BLUE BIRD

SUBJECT: SERVICE BULLETIN S10RA BODY CONTROL MODULE

AFFECTED: 2010 D3FE AND D3RE All AMERICAN

Body Control Module

Body Control Module

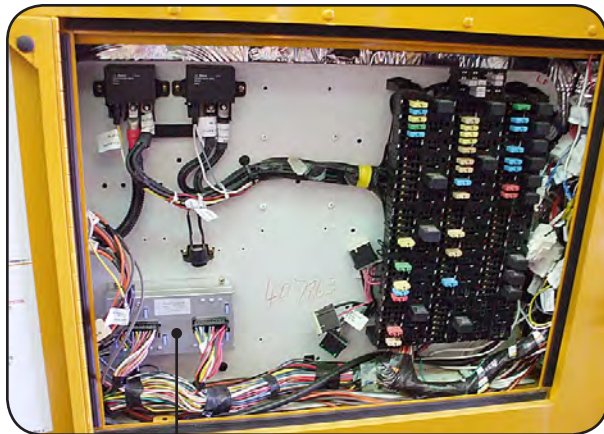
Affected buses, under certain conditions may exhibit any or all of the following symptoms related to the Body Control Module: Blown number 5 fuse. Windshield wipers sweep when the Ignition Switch is on and wiper switch is off. Stop arm activates when the Ignition Switch is switched on.

2 Locate the Body Control Module serial number at the bottom left corner of the module. If necessary, remove the mounting screws and carefully shift the module to gain view of the serial number. Compare the serial number to the list on page 2.

3.1 Disconnect the harness plugs from the module. Remove the top two mounting screws, and loosen the bottom two mounting screws. Remove the module.

3.2 Refer to the list on page 2 to determine whether the replacement is 10001559 or 10002011. Place the new module over the bottom two mounting screws. Reinstall the two upper mounting screws. Tighten the four screws. Connect the harness connectors.
